Issue	**1**
Factory ID	**26347**
Date of Issue	**22-Apr-2026**

Select Enterprise

Fire Safety Inspection Report

Pakistan Accord Initial Safety Inspection Report

Figure 1.4. Egress Layout of Main Building

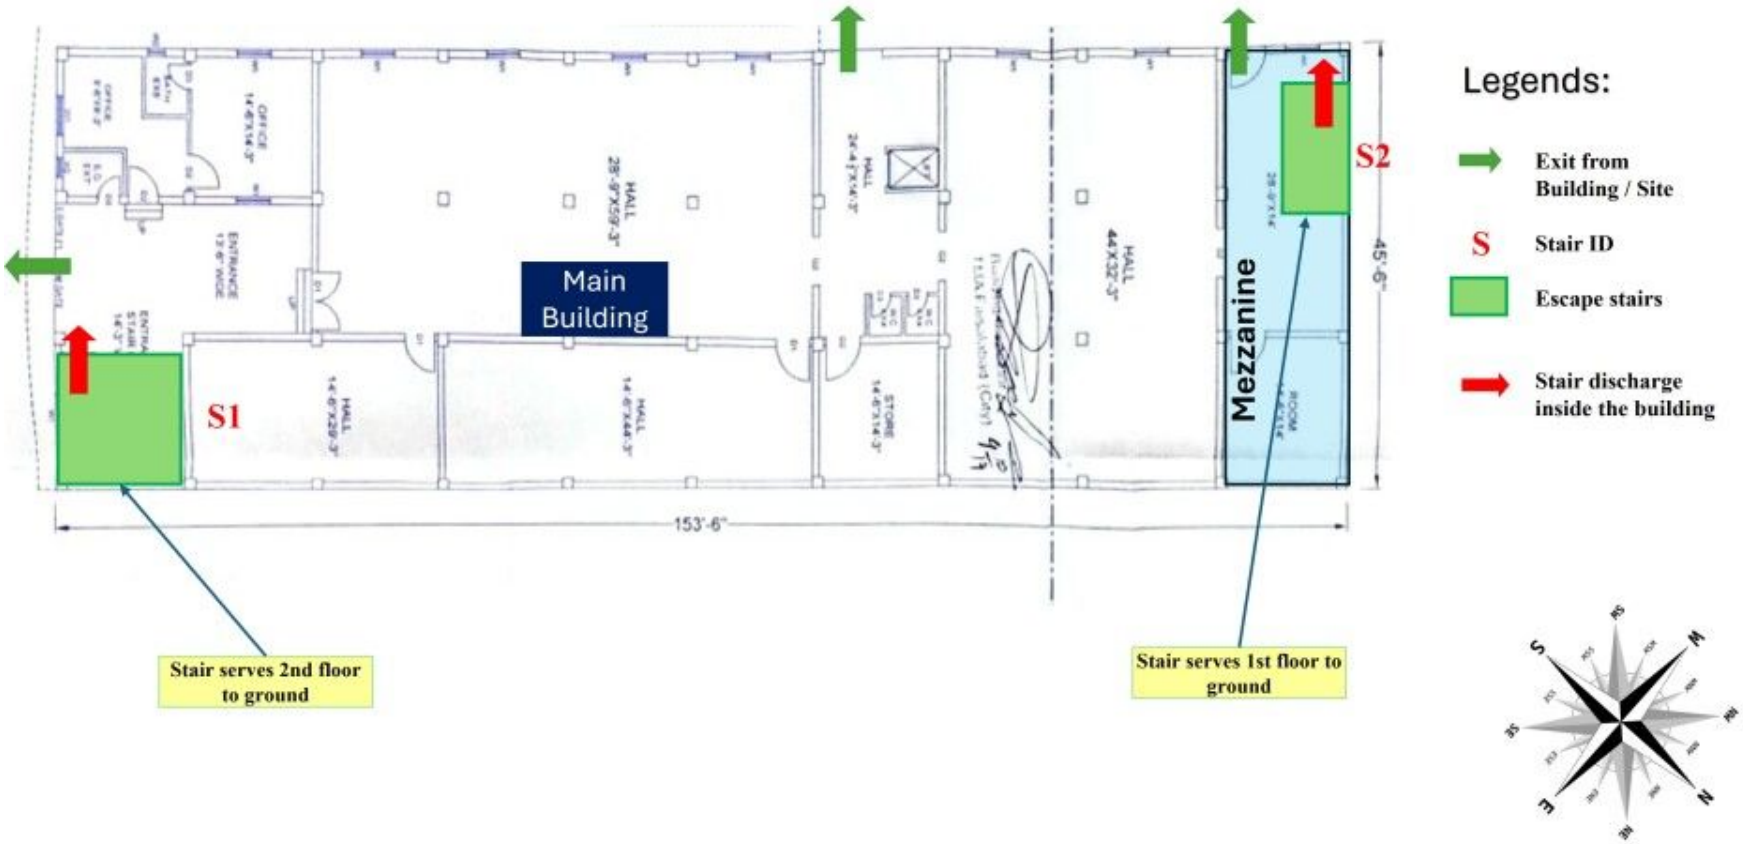
The number of exits is sufficient at Main Building. No excessive common path was observed in the Main Building.
